TORQ-MATIC WRENCH  
PRODUCT BULLETINS

<b>Product Bulletin #</b>	<b>Subject</b>	<b>Page</b>
Wrench 001	Leaking Fittings within the hydraulic valve Banks	5
Wrench 002	Cylinder Gusset Failure on Main Boom	6
Wrench 003	Orientation of spinner roller seals	7
Wrench 004	Shearing Belleville Stack Mounting Studs	10
Wrench 005	Inspection of Main Boom Pin Tube and Support Gussets	15
Wrench 006	High Pressure Control Seats for Hydraulic Valve	24
Wrench 007	Inspection of Vertical Lift Channel	27
Wrench 008	Tong Cylinder Orifice	27
Wrench 009	37-Pin Cable and Receptacle Cap Plugs Getting Pinched	30
Wrench 010	Cable Guide / Encoder Guard	33
Wrench 011	Locking Joystick on Driller's Console	37
Wrench 012	Sealed Electric Operator for Horizontal Extend/Retract Valve	42
Wrench 013	Tong Cyliner Upgrade	56
Wrench 014	Wrench Lifting Procedure	61

WRONG WAY TO INSTALL THE SEAL,CAVITY FACING DOWN

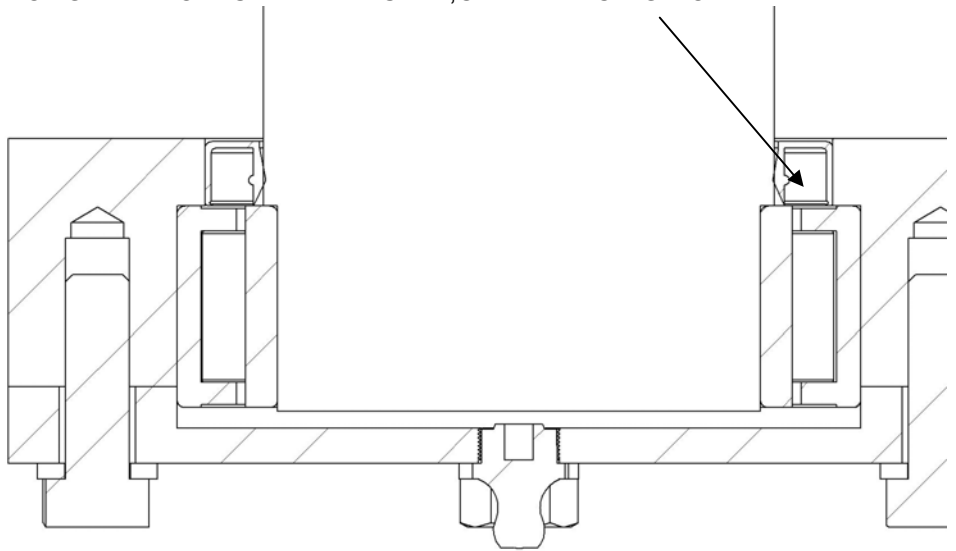
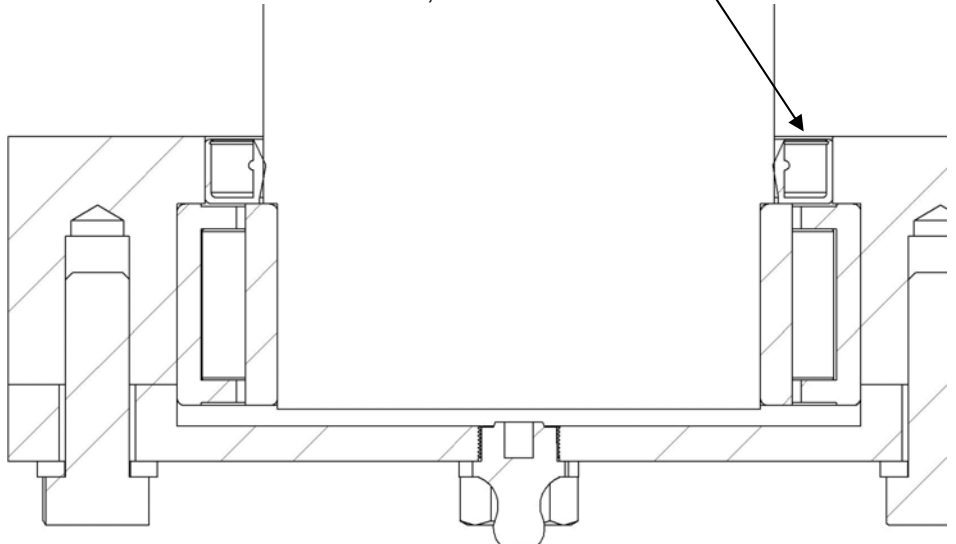
**DISCUSSION:** CANRIG has discovered that early production units of the TM-80 may have had the grease seals installed upside down. This prevent excess grease and pressure from exiting the cavity and may eject the seal or push the roller shaft up.

RIGHT WAY TO INSTALL THE SEAL,CAVITY FACING UP

Check seal orientation by greasing spinner roller shafts, grease should come out under rollers. If not the seal is installed upside down, unscrew grease nipple to release excess pressure.  
Contact CANRIG to ship 4 of seal P/N S10104 and 4 of bearing P/N M10644  
See DWG # 188200005 for installation instructions.

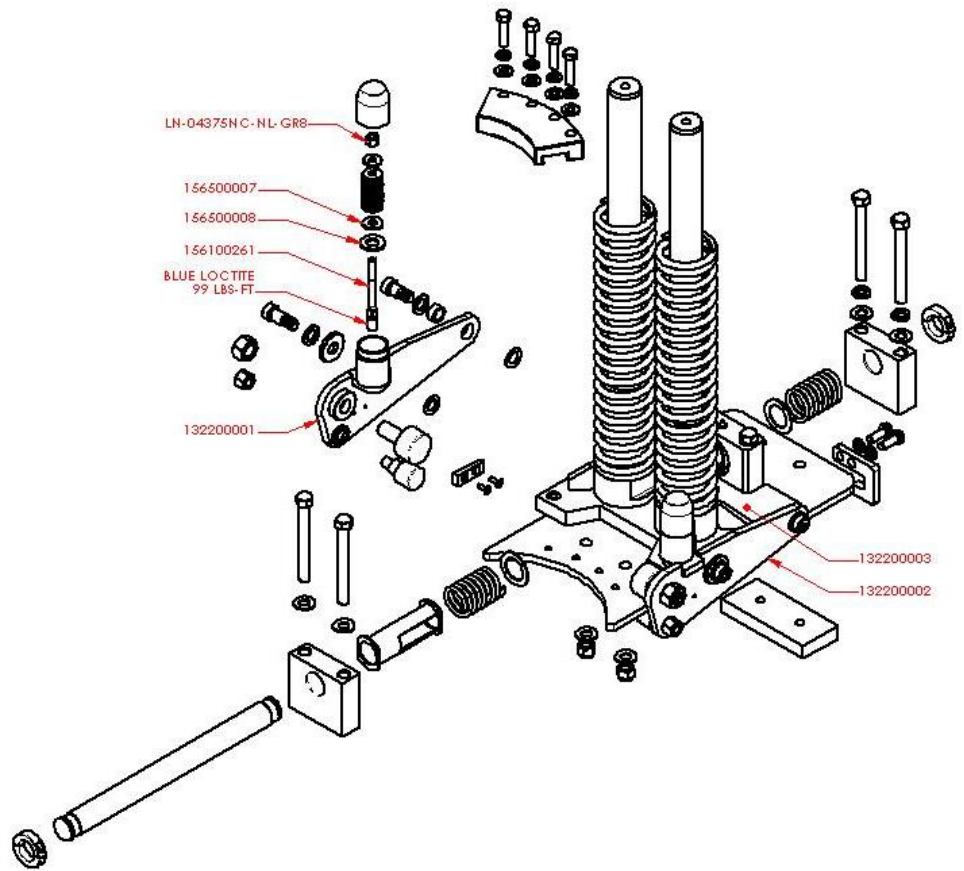
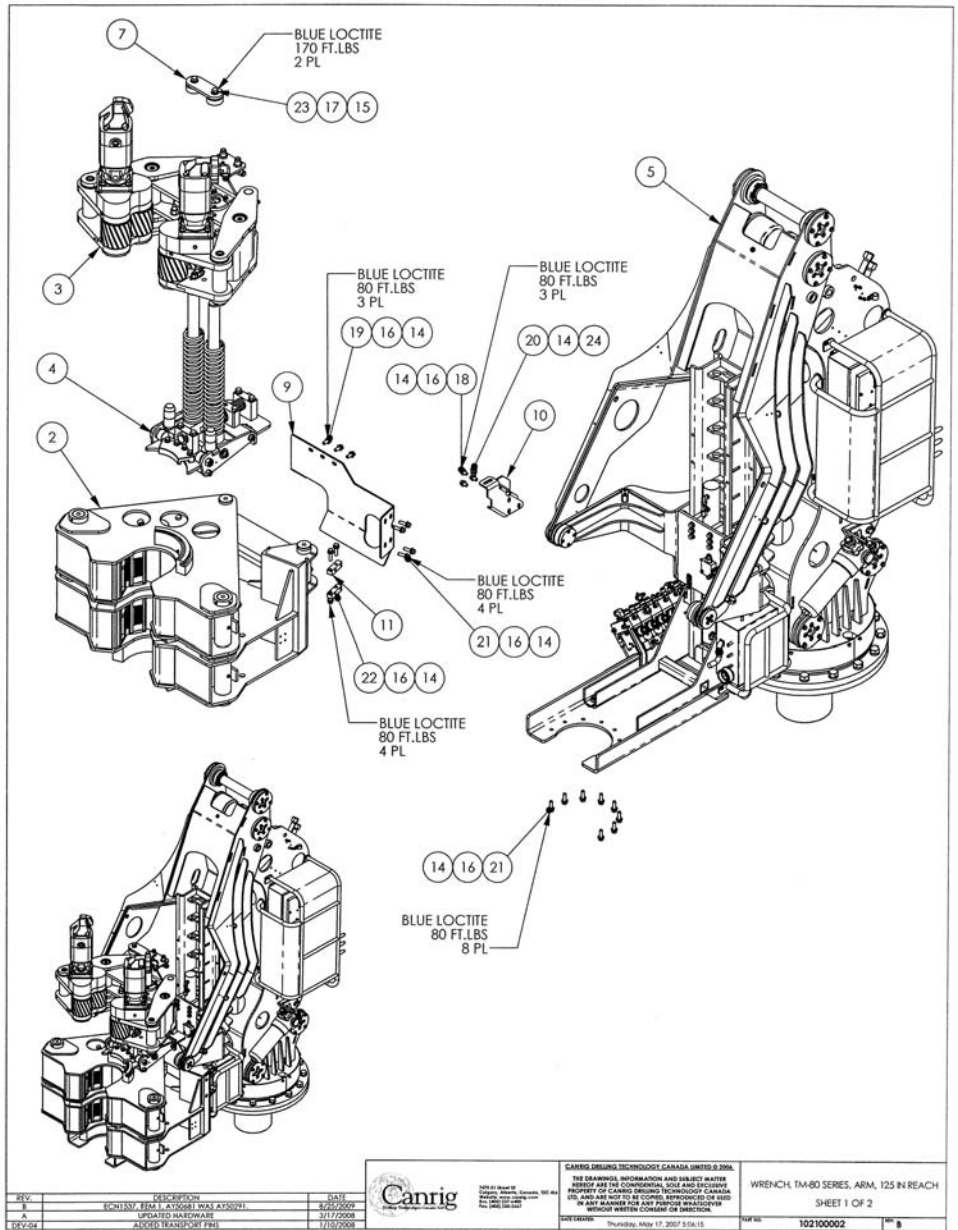
**DISCUSSION:** There is a potential for the mounting stud for the Belleville Washer Stack to shear at the thread where it is screwed into the Jeep Carriage Frame.

**RECOMMENDATION:** It has been determined that there is a possibility the Belleville Mounting Studs on the Jeep Assembly will shear. If this happens, the Spinner/Jeep Assembly will lean at an angle towards well center rather than vertical. Clamping onto drill string in this position will cause the Spinner/Jeep Assembly to violently snap into position, causing damage to the Jeep Assembly, Link Arms and Jeep Rear Mounting Plate.

The "Frame, Jeep Carriage, TM-80", left and right "Side Arm, Spinner Track Jeep", "Stud, Mounting, Belleville Washer Stack" are modified designs that need to replace the old parts. Also, there are 2 washers made from UHMW that need to be installed under the Belleville Stack to allow free movement of the assembly.

In order to complete the retrofit, the kit needed is:

1 EA – 112200008 – KIT, RETROFIT, BELLEVILLE MOUNTING STUD

Figure 1

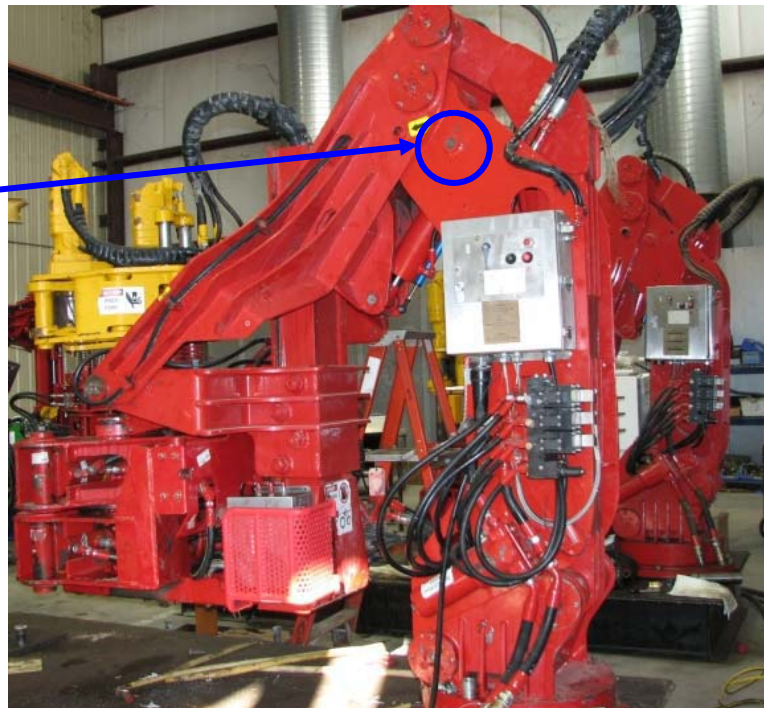
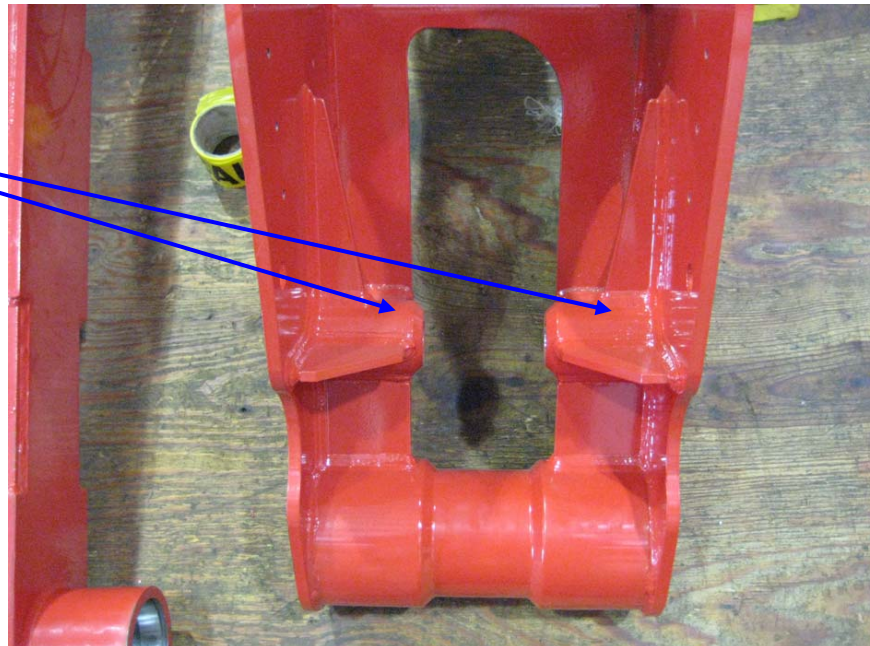
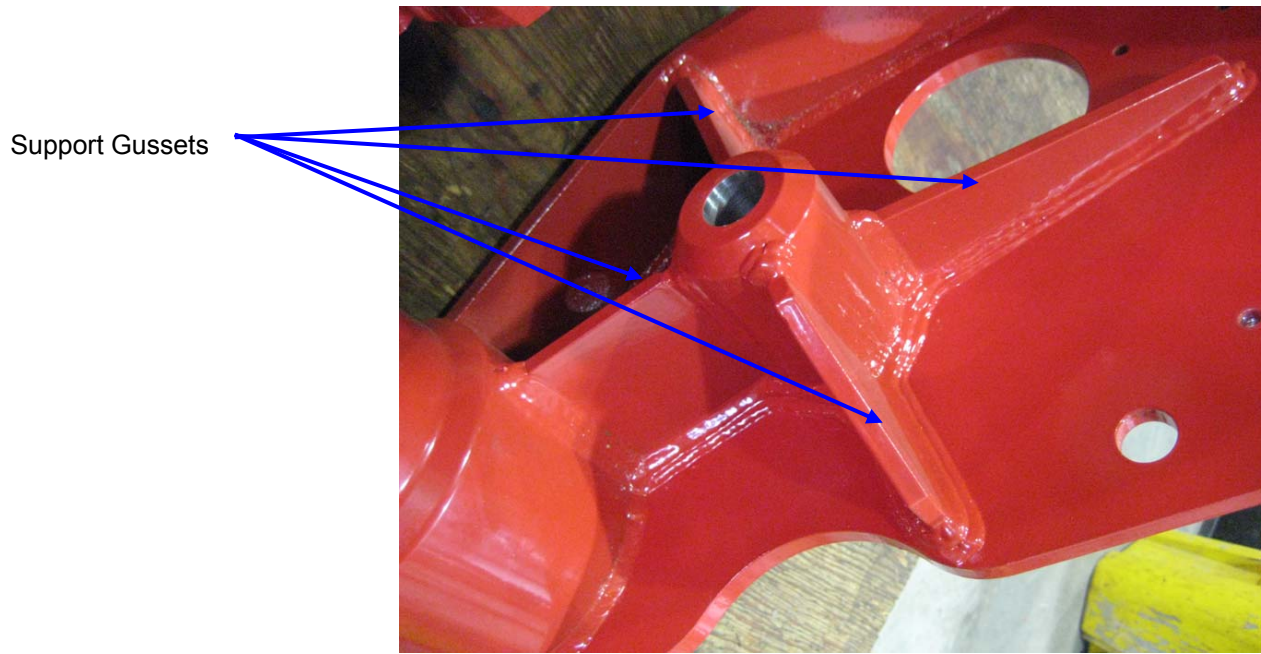
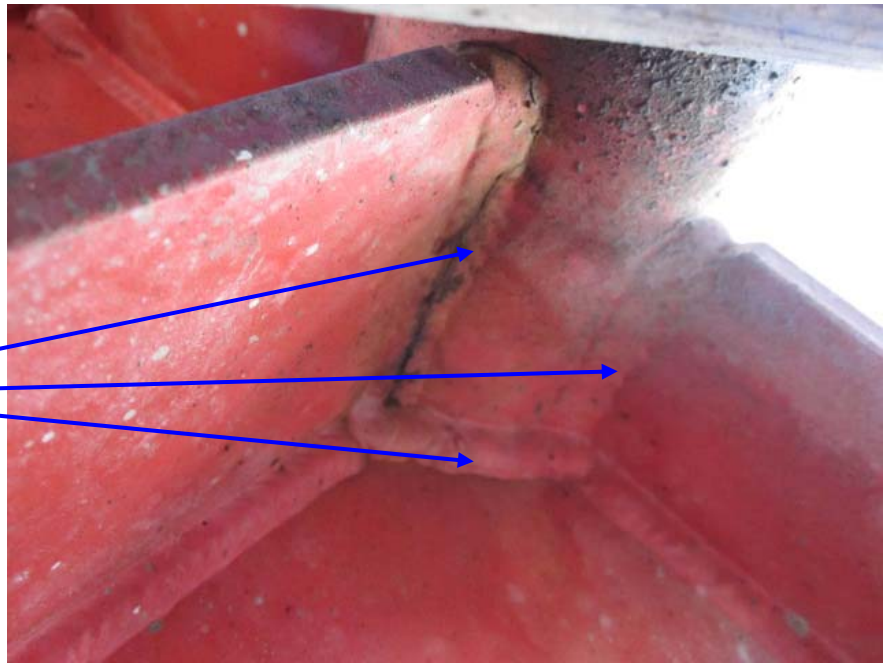
**DISCUSSION:** In two isolated instances, rig crews in the process of servicing a TM-80 (110" reach) wrench, discovered cracks along the welds connecting support gussets to the horizontal cylinder pin tubes located near the top of the main boom. Both wrenches had been in operation for over a year.

Figure 1 shows the location of the pin tube on the main boom. Two halves of the pin tube are welded to the insides of the main boom side plates. The horizontal cylinder is secured between the tubes with a 1 1/4" pin and is used to extend the wrench tong assembly over the well.

Examination of the weld joints revealed voids between the support gussets and pin tubes, poor penetration of the weld into the gusset material, and lack of weld fusion with the pin tubes. Canrig estimates that the inferior quality of the welds could have reduced the maximum allowable stress in that area by as much as 70%. Because the weld deficiencies were hidden underneath the weld, they

1. Conduct inspection of the wrench following the below steps.
  - a. Extend the wrench out far enough so that the vertical can be fully lowered down and carefully set on the floor, without putting stress on the vertical cylinder.
  - b. Disconnect power. Follow local tag out and lock out procedures. Remove any valve hand controls if installed.
  - c. View main boom from underneath with flashlight and inspect main pin tube and supporting gussets for cracks in the welds. Clean the area around the pin tubes and support gussets if necessary for better visibility
  - d. Using a step ladder and flashlight, perform similar inspection from above main boom.
  - e. Inspect pin tube and weld from the outside on both sides for cracks or evidence of buckling.
  - f. Figures 2 and 3 below indicate the areas of inspection.

- g. Evidence of cracking at the weld joints between the pin tube and support gussets is indicated in Figures 4 and 5 below.

2. If you find evidence of cracking at the weld joints similar to that depicted in the above images, contact the Canrig Service Support Department immediately for an assessment. Contact information is provided below.

Figure 1: TM-80 Tong Valve Bank

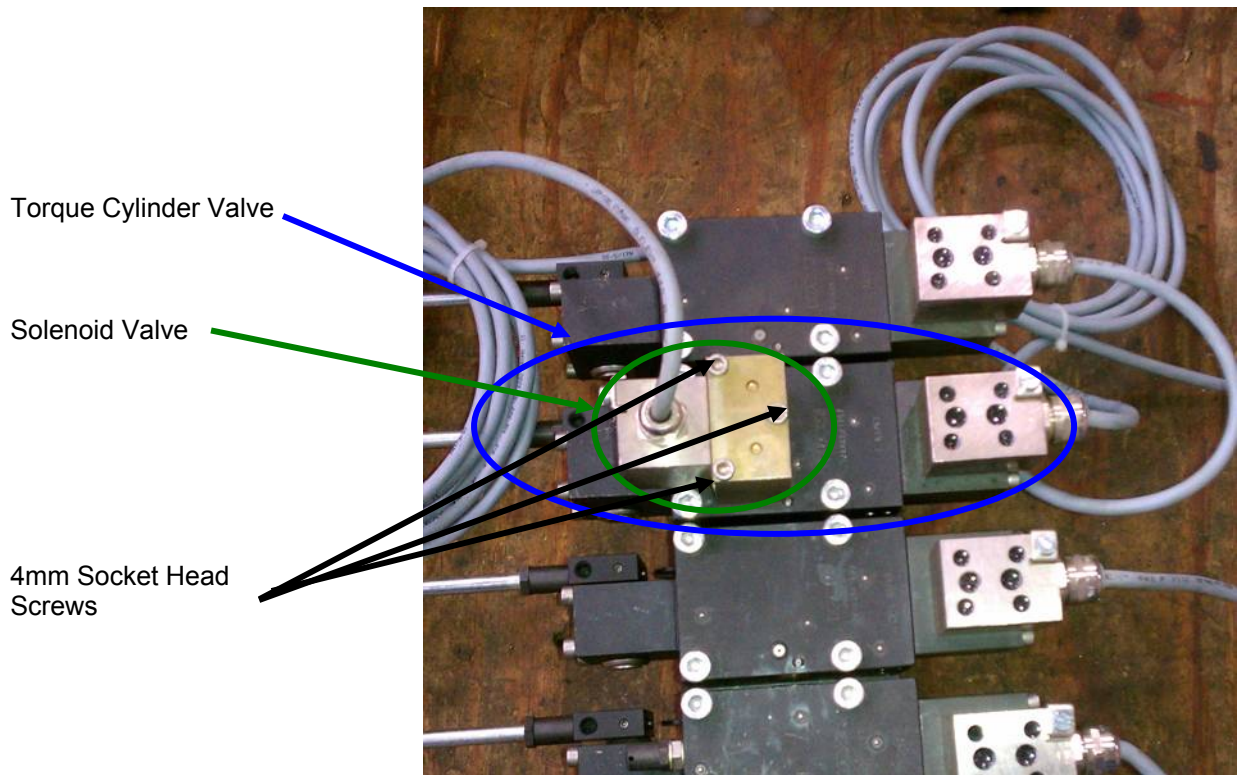
Hydraulic control valves for Torq-Matic wrenches have been installed by Canrig with pressure control seats on the torque cylinder valve rated for 320 bar (4641 psi). However, the wrench torque cylinder may operate at hydraulic pressures up to 355 bar (5150 psi). At higher operating pressures, the pressure control cones (darts) have a tendency to stick and cause the valve to malfunction.

Replacing the pressure control seats and cones as well as associated o-ring seals with the higher pressure versions will increase the pressure rating of the valve from 320 bar to 355 bar. These components should be replaced during the next available maintenance period.

Kit part number AY50784 contains the components necessary to replace the existing components with equivalent high pressure components. The AY50784 kit can be used for both the TM-80 and TM-120 and includes the following items:

**Figure 2**

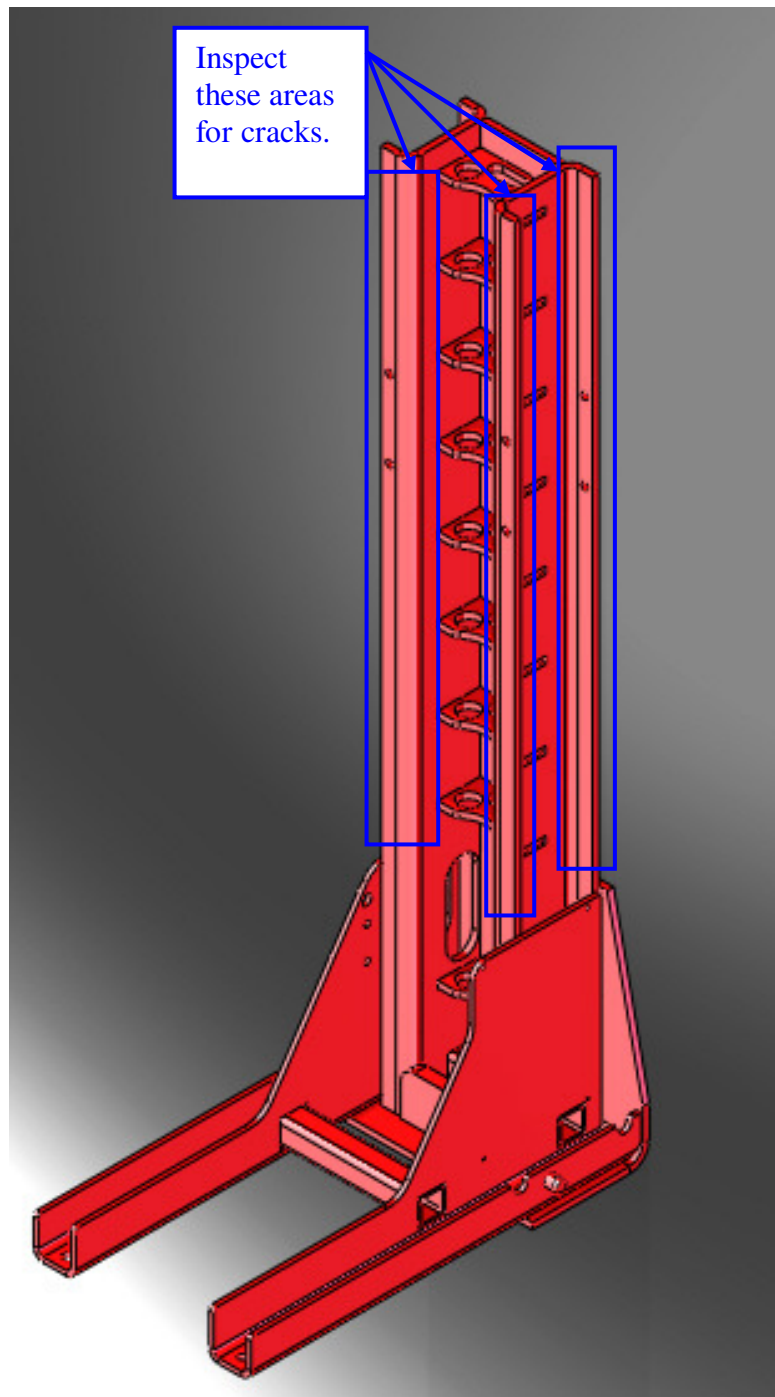
**DISCUSSION:** In a few isolated instances, rig crews have discovered cracks in the Vertical Lift Channel located approximately one third to halfway from the base of the channel. Probable cause of these cracks is most likely a result of repeated excessive loading or a singularly large impact load beyond normal operation of the wrench.

Figure 1 and Figure 2 indicate the areas of inspection for cracks on the Vertical Lift Channel.

1. Conduct inspection of the wrench following the steps outlined below.
  - a. While the wrench is in or close to the park position, fully raise the Vertical Lift Assembly
  - b. Disconnect power and follow local lock out and tag out procedures and remove any valve hand controls if installed.
  - c. Inspect the upper half of the Vertical Lift Channel for any sign of cracks. Clean the area in the channels for greater visibility if necessary.
  - d. Reconnect power to the wrench to move the assembly so that the bottom half of the Vertical Lift Channel can be inspected.
  - e. Extend the wrench out far enough so that the vertical can be fully lowered down and carefully set on the floor, without putting stress on the vertical cylinder.
  - f. Disconnect power. Follow local lock out and tag out procedures.

- g. Inspect the bottom half of the Vertical Lift Channel for any signs of cracks. Clean the area in the channels for greater visibility if necessary.
2. If you find evidence of cracking, as shown in Figure 3, contact the Canrig Service Support Department immediately for an assessment. Contact information is provided below.

**Figure 1**

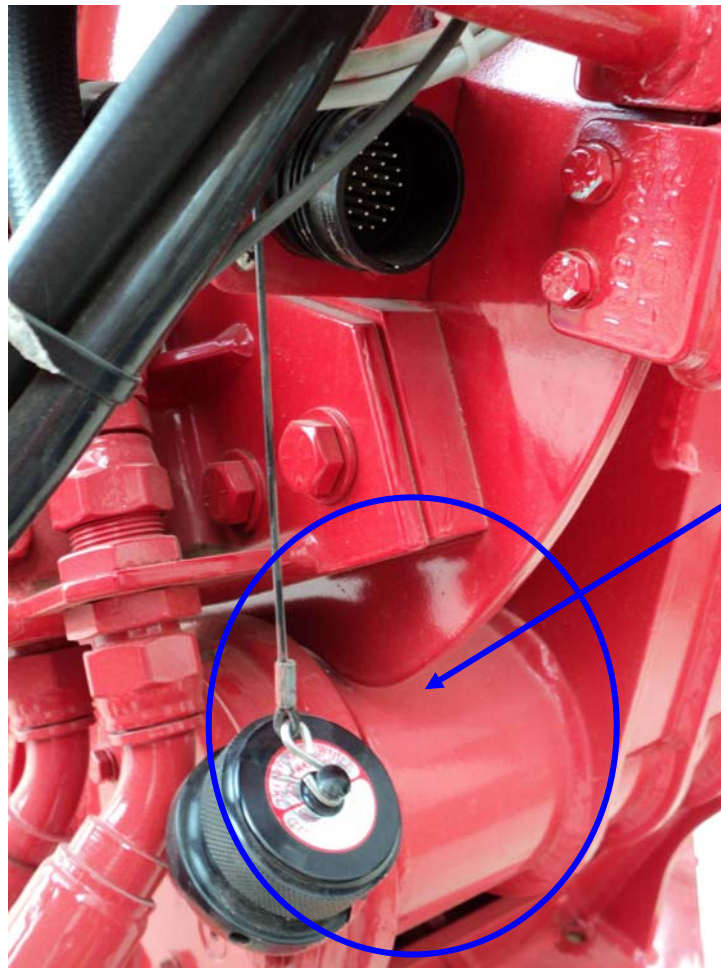
**DISCUSSION:** Both the receptacle for the wrench arm junction box and the 37-pin conductor cable which connects the PLC control panel to the wrench arm junction box are supplied with protective cap plugs. Once the cable is connected to the receptacle, these cap plugs (hereafter referred to as the receptacle cap and cable cap) will hang loose and have the potential to become pinched between the wrench main boom and base during operation. See Figure 1.

The receptacle cap and cable cap can become trapped and crushed here.

- Connect the 37-pin cable and then feed the receptacle cap around the hydraulic hoses to the left of the connection and screw the receptacle cap onto the cable cap.

- Connect the 37-pin cable and then screw the receptacle cap onto the cable cap.

**Figure 1: TM-80 without Cable Guide/Encoder Guard**

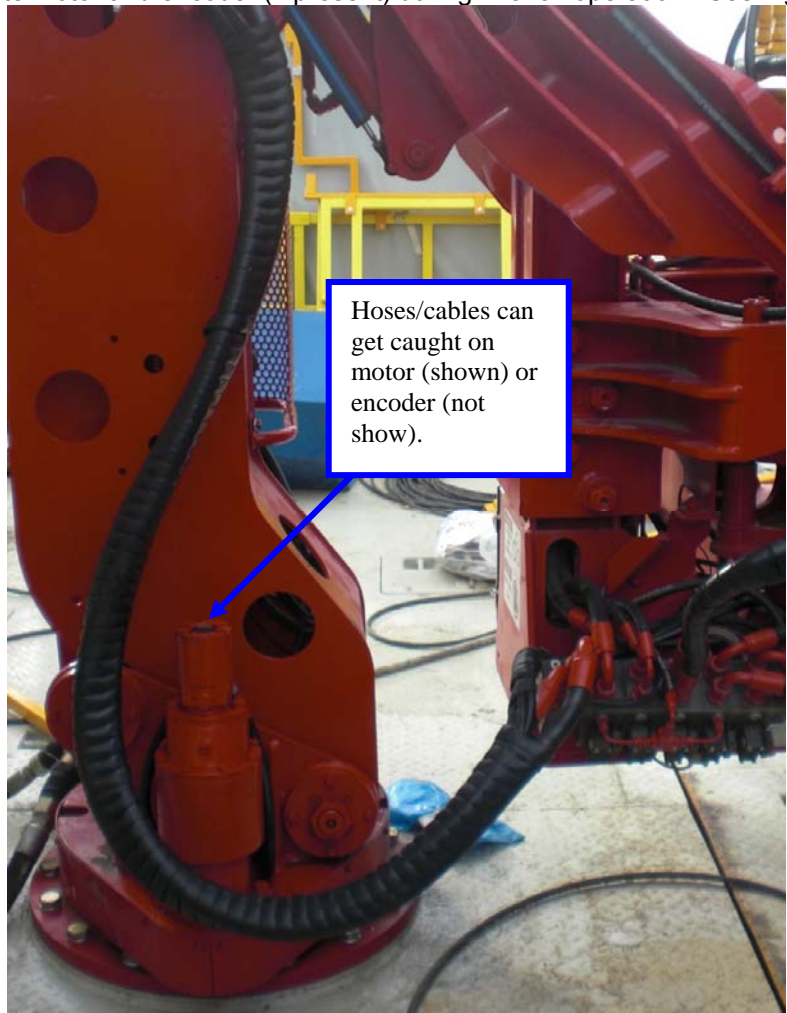
**DISCUSSION:** There is potential for the hydraulic hoses and cables to become trapped behind the rotate motor and encoder (if present) during wrench operation. See Figure 1.

Installing the Encoder Guard will help prevent cables and hoses from catching on the motor or encoder as well as providing added protection during standard rig operations. See Figure 2.
